SUBJECT: COMANCHE PEAK NUCLEAR POWER PLANT, UNITS 3 AND 4
DOCKET NUMBERS 52-034 AND 52-035
RESPONSE TO ENVIRONMENTAL REVIEW QUESTIONS ALT-03 AND SOC-33, AND
SUPPLEMENTAL INFORMATION FOR QUESTION TE-04

Response to Request for Additional Information Regarding the Environmental Review

RAI REGARDING THE ENVIRONMENTAL REVIEW

Figure 1: Monthly Median Simulated Flow at Brazos River near Glen Rose Gage Scenarios A and C – 2020 Conditions

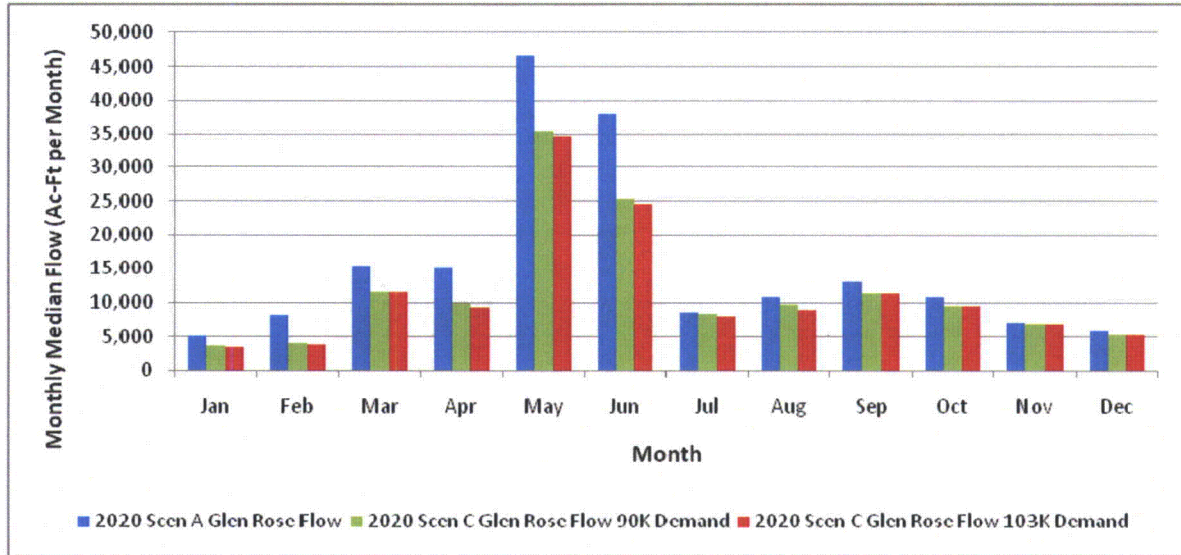
- The impacts of operating CPNPP Units 3 and 4 on water quantity and quality in the Brazos River downstream of the CPNPP site. How many miles downstream would the impacts extend?

Decreased flows in the Brazos River downstream of Lake Granbury are expected as a result of CPNPP Units 3 and 4 operational water use. This change is primarily the result of less frequent spills from Lake Granbury during periods of high flow. Modeling performed simulating the effect of Units 3 and 4 water use on downstream flows at the Brazos River Glen Rose stream gage indicates the greatest decreases in flow would be in May and June, months that typically have the greatest flow (Figure 1). From the perspective of irrigators or other small users of the river, there should be a sufficient quantity of water during periods of high flows, and a reduced frequency of flood flows may actually be beneficial. Water quantity during periods of low flow should be similar because Lake Granbury would be impounding inflows as reservoir levels drop. Increased periods of low-flow could impact irrigators or other small users and are an important factor when considering environmental justice. According to the modeling, average monthly flows less than 100 cfs would occur about 80 percent of the time before the new units come on-line (Figure 2). When the new units come on-line the frequency of these flows would increase to about 82 percent of the time. Average monthly flows of less than 10 cfs would change from occurring about 39 percent of the time to about 44 percent of the time. These changes show only a SMALL impact from an environmental justice perspective.
